*BEACON PLANNING BOARD*  
*One Municipal Plaza - Courtroom*  
*BEACON, NEW YORK 12508*  
*Phone (845) 838-5002 Fax (845) 838-5026*

The Planning Board will meet on **Tuesday, May 9, 2017** in the Municipal Center Courtroom. A work session will take place at 7:00 PM for a training workshop, discussion of agenda items and/or topics of interest to the Planning Board. The regular meeting will begin immediately thereafter, but not later than 7:30 p.m.

**City of Beacon Planning Board**  
**5/9/2017**

**Site Plan**

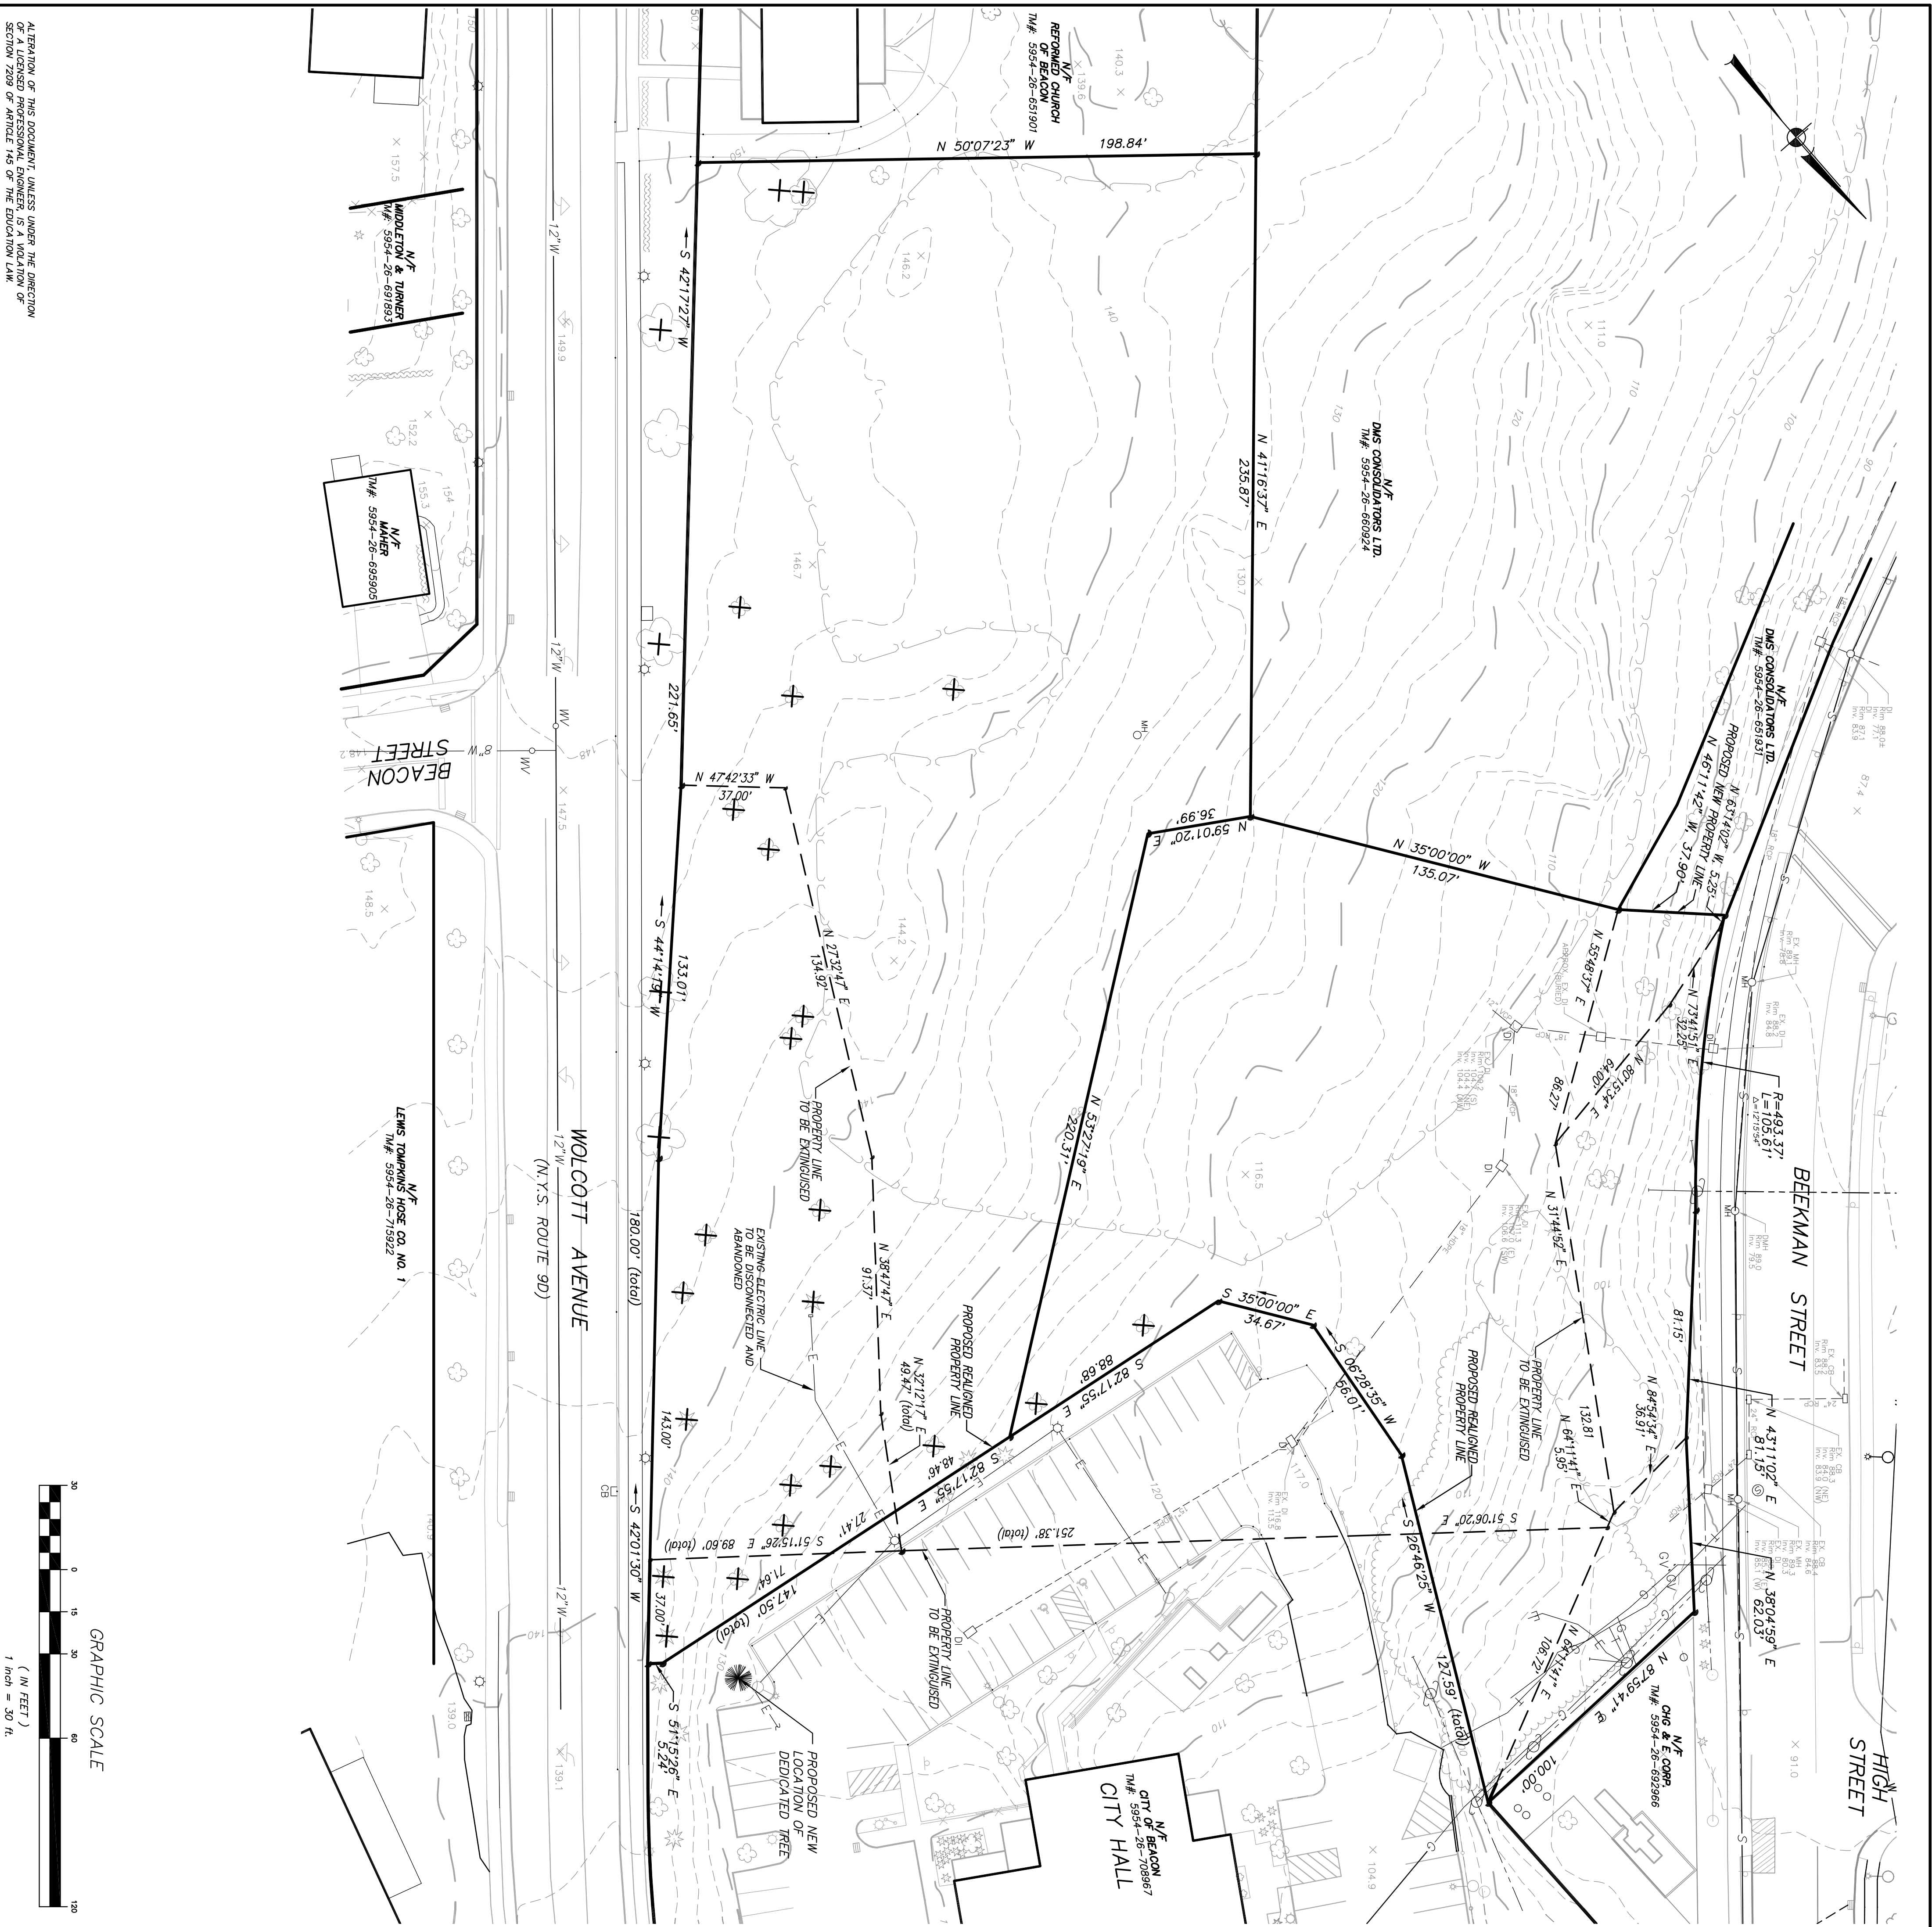
5. Drawing SP-1 has been revised to expand the proposed snow storage areas as requested. We understand that Note #1 on Drawing SP-1 will be discussed further with the Planning Board and Building Inspector.

**DRAWING NO.:** SP-2.1  
**SHEET:** 4 / 13

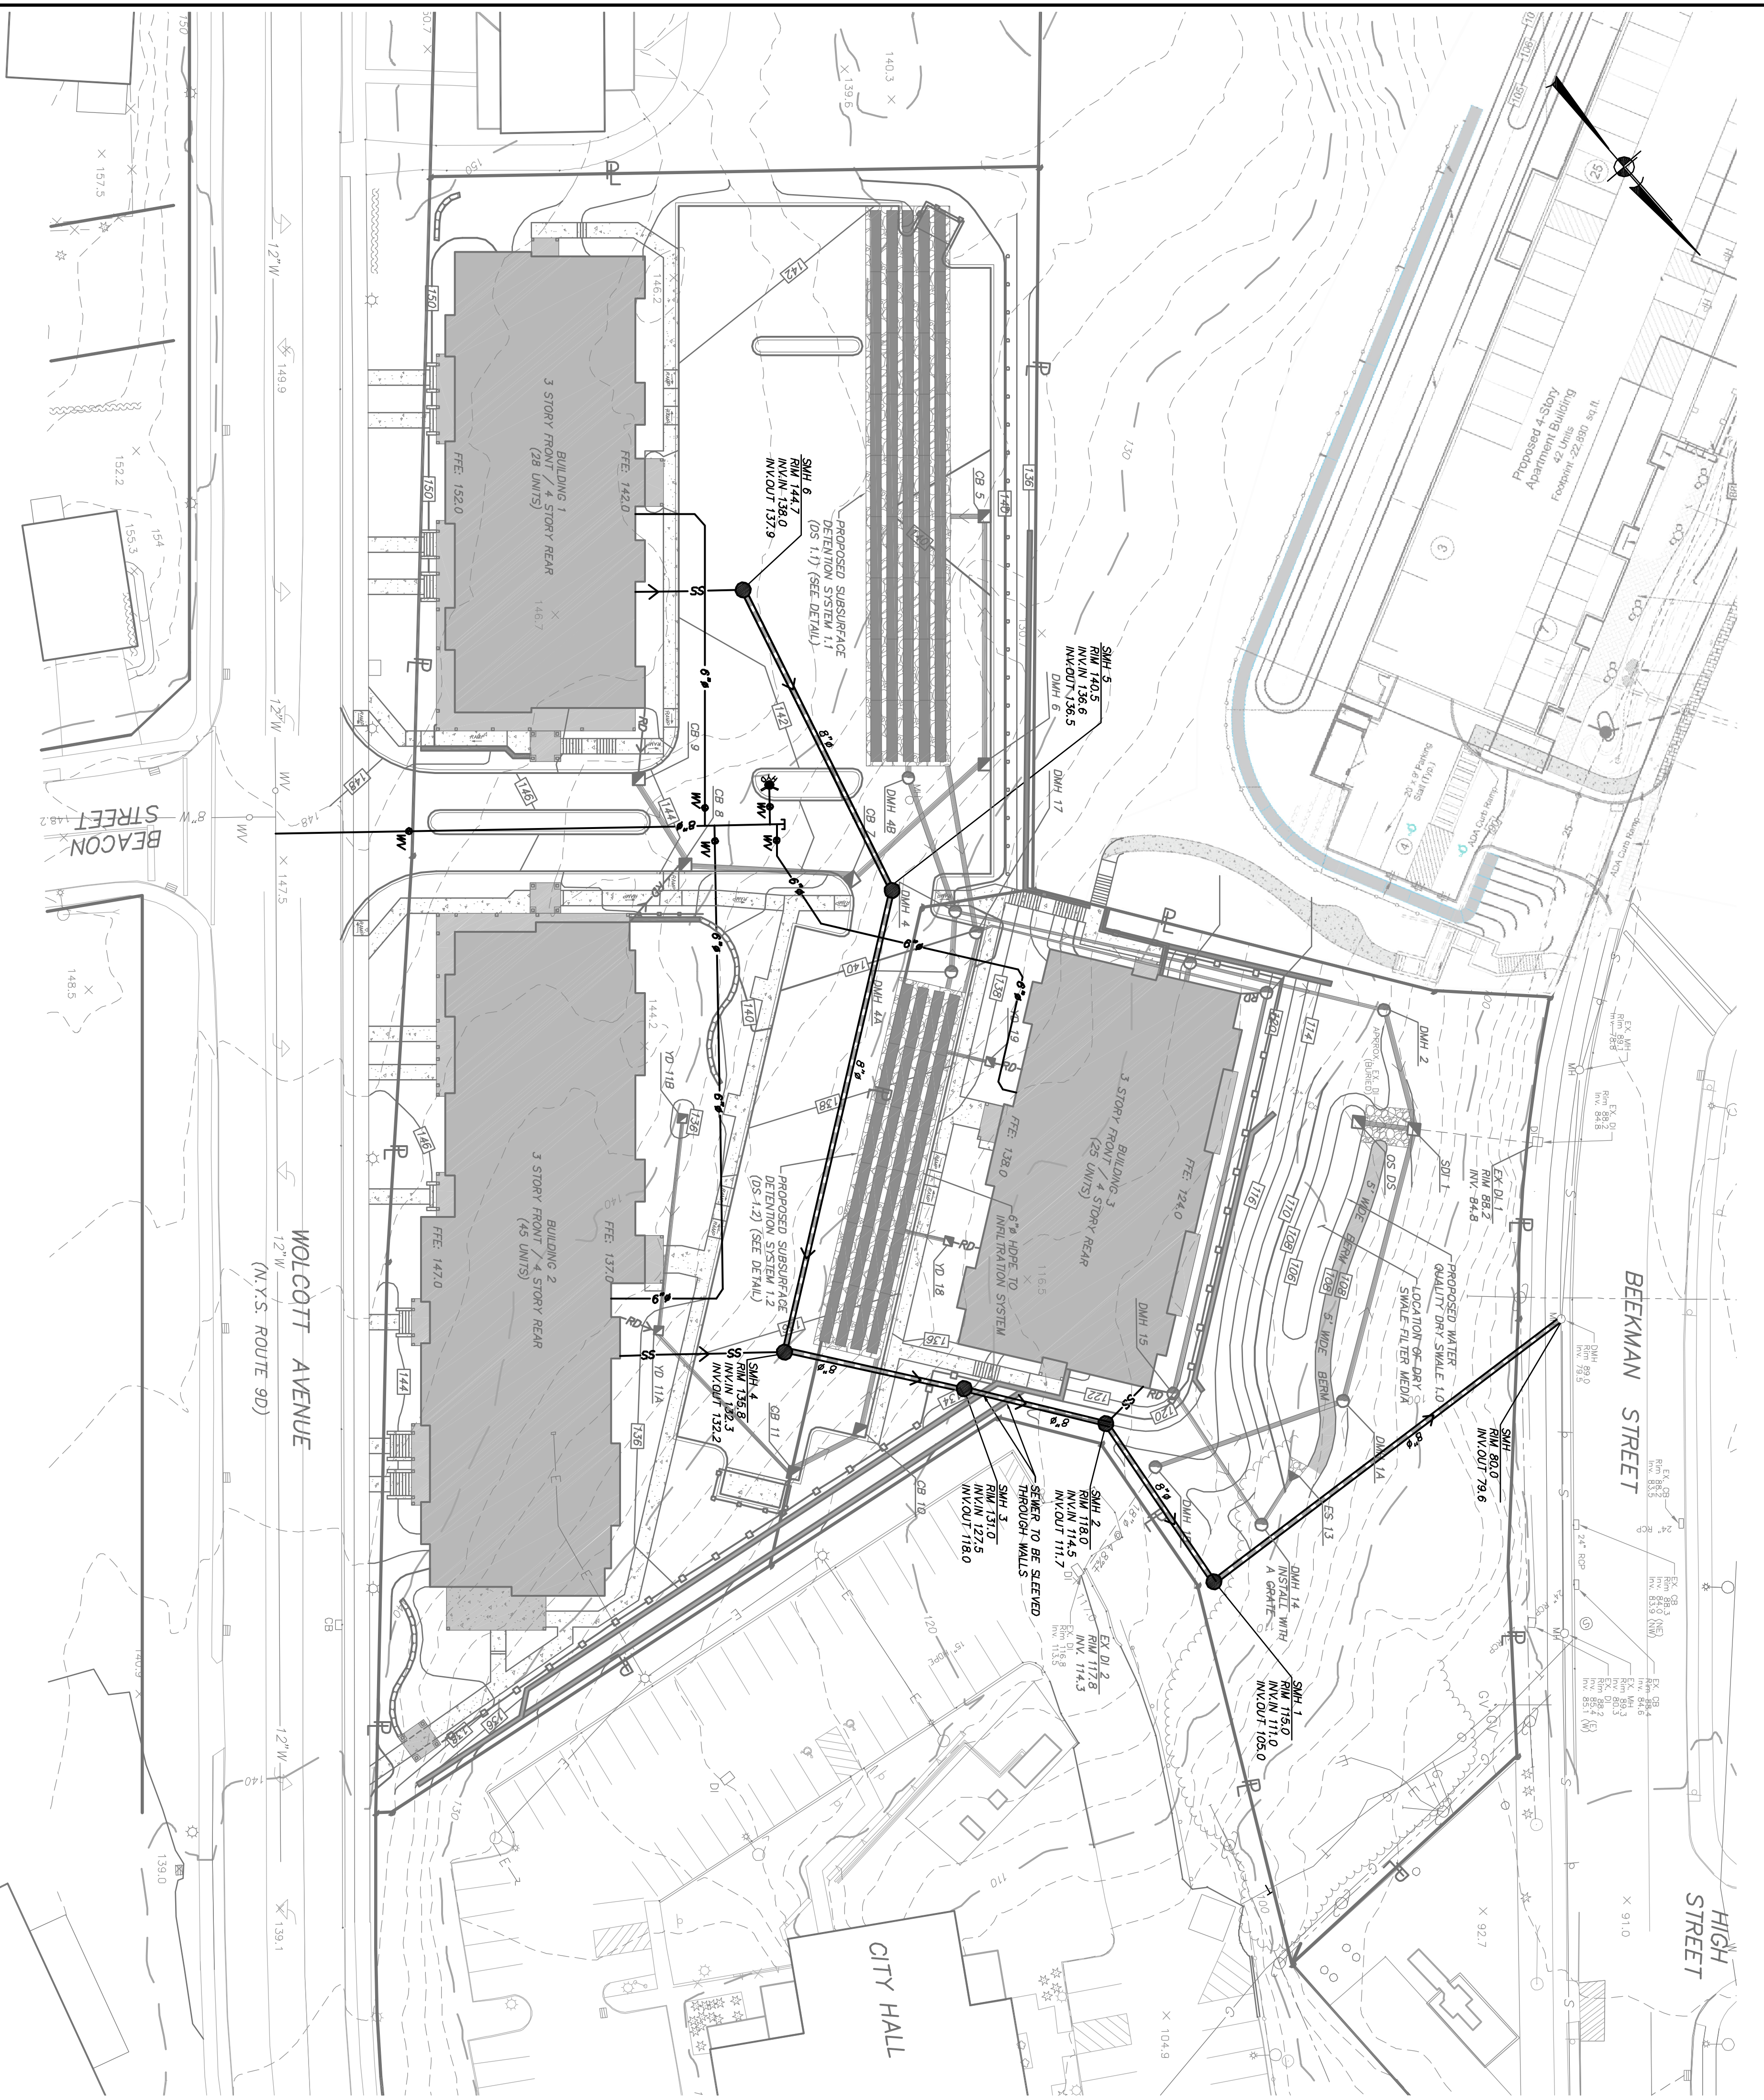
3. The drainage table has been revised to match the drainage structures shown on the project plans.
4. The elevations on shown the stormwater details on sheet 13 of 13 have been revised to match those shown on the drainage table on the Grading and Drainage Plan.
5. As shown in the enlarged grading and drainage plan view, the stormwater piping around Building #3 has been shifted slightly to provide horizontal separation between the proposed structures and piping.
6. The plan has been revised show additional grading and lower the rim elevation of yard drain YD11B to ensure the area west of Building #2 drains away from the building towards the drain.
